ADDENDUM # 1**Renovation of Commons A**

WBA 21-034.01

TO: All Bidders**DATE: 20 January 2023**

LEVEL I - DEMO RCP
SCALE: 1/8" = 1'-0" REF: 1/11 X 17 P

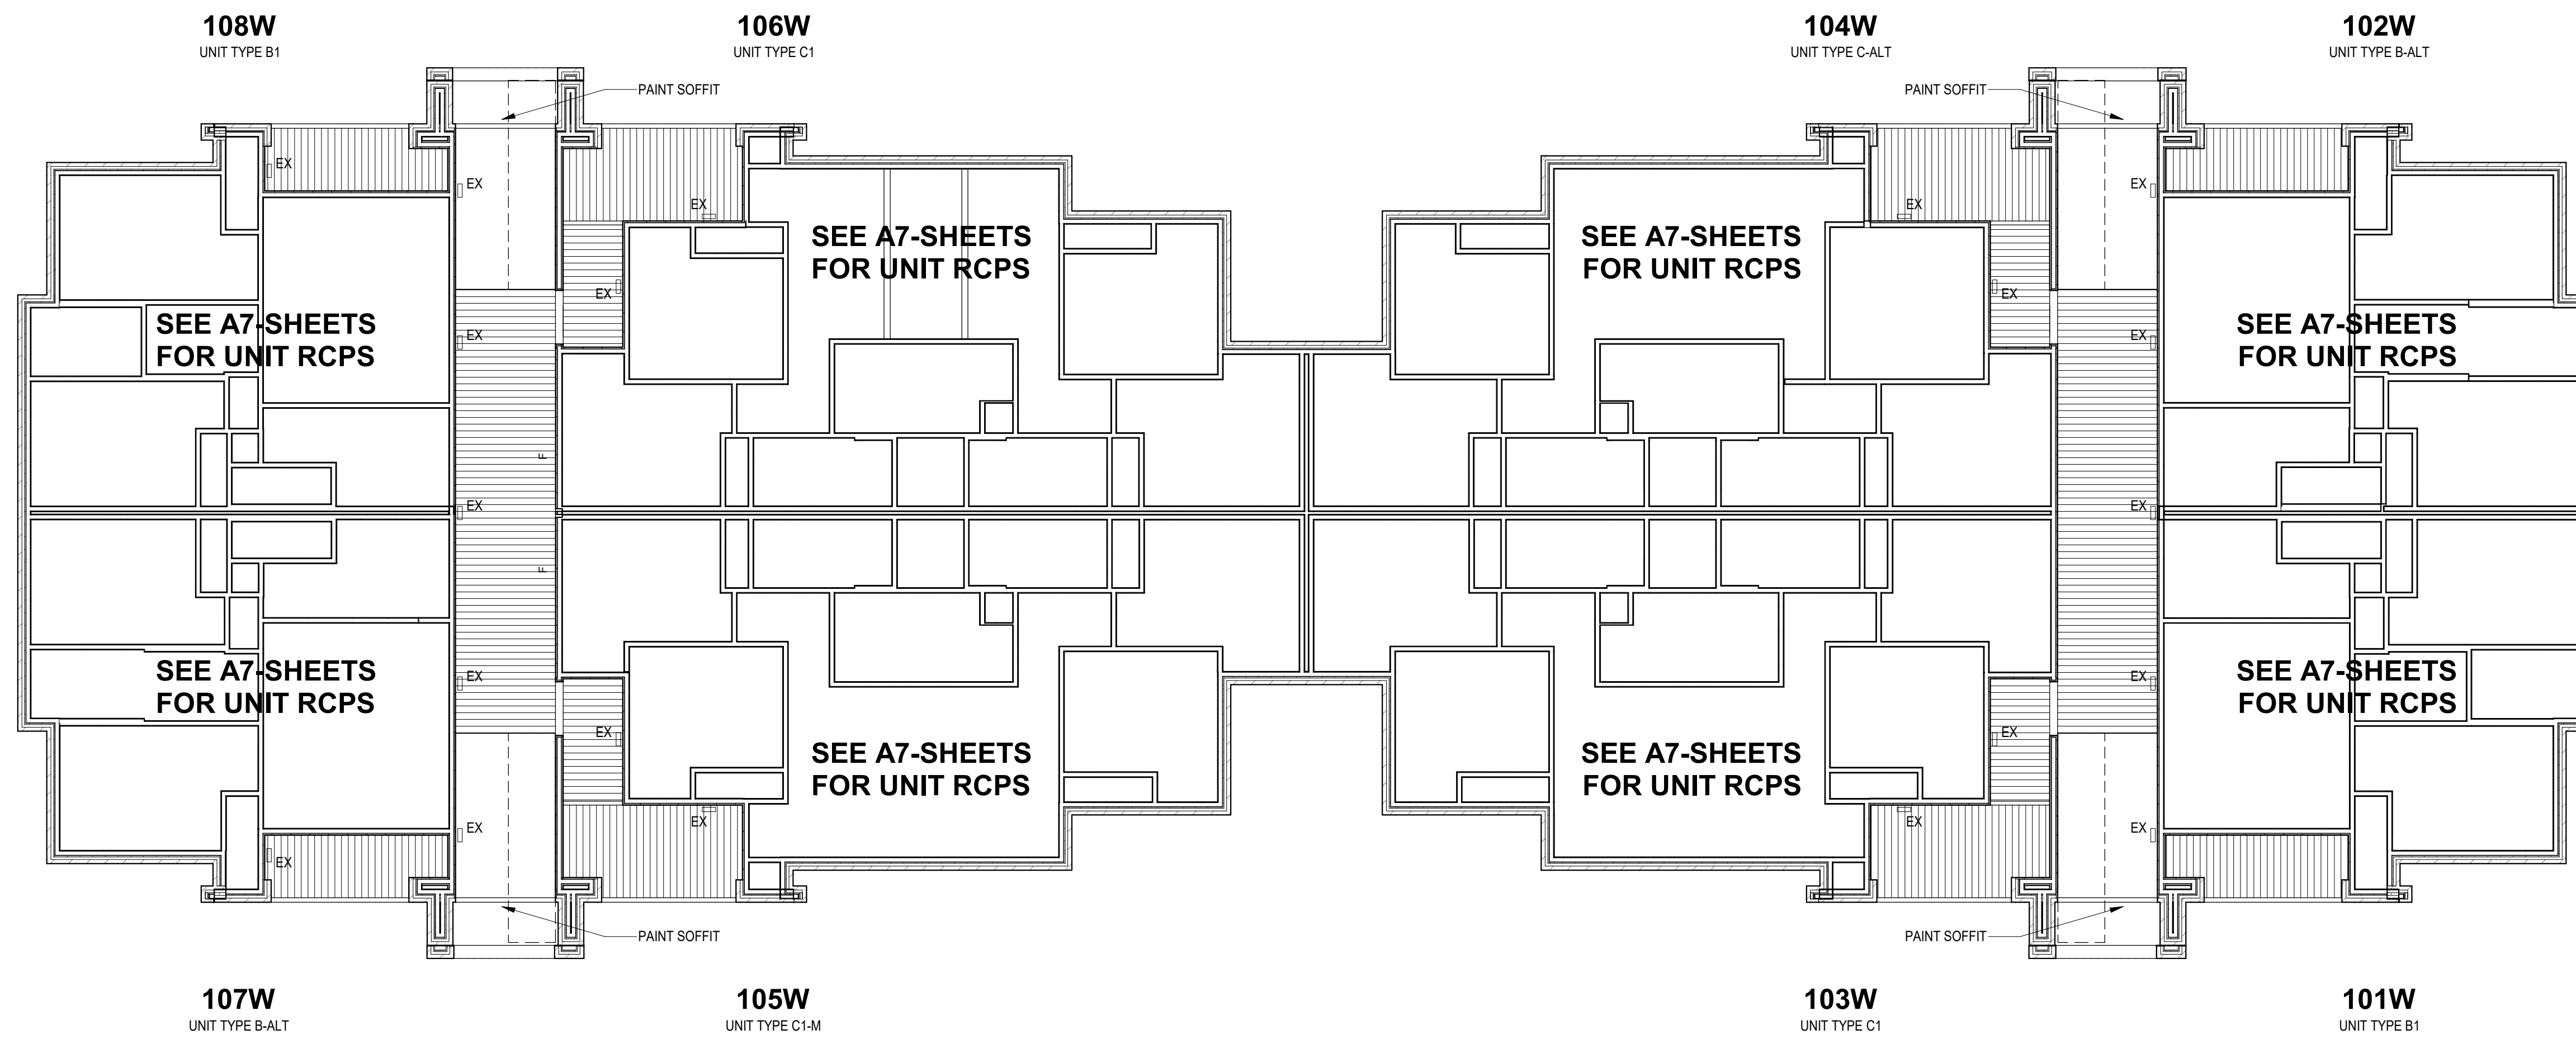
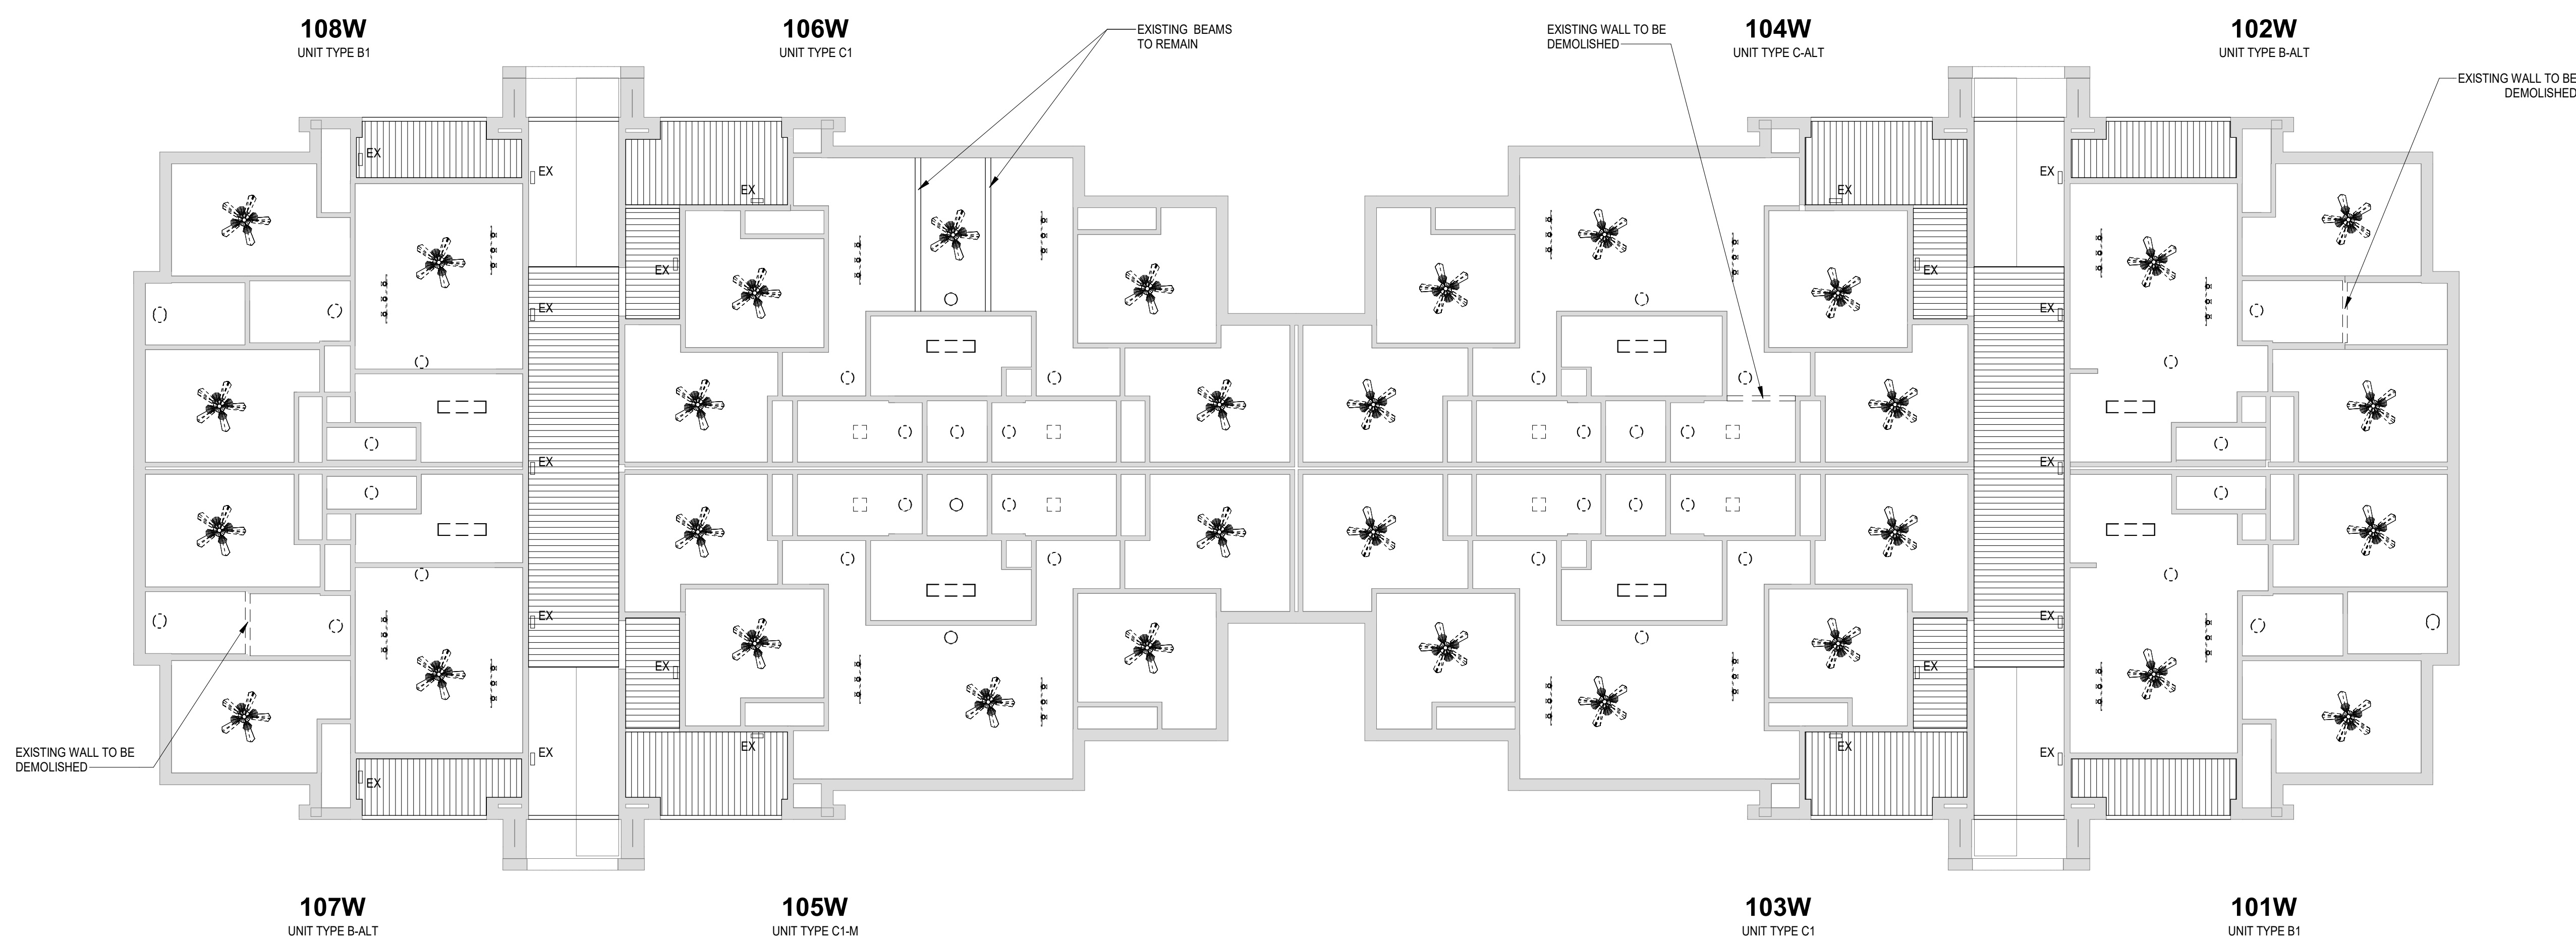
15. Question: The ceiling demolition key does not appear to be used; please confirm if this should be utilized?
- a. Response: The Pre-Demolition Scope has already been completed under a separate contract. Please refer to revised sheets A3.1, A3.2, and A3.3.

16. Sheet A3.1 / A3.2 / A3.3: Replaced pre-demolition notes with demolition notes.
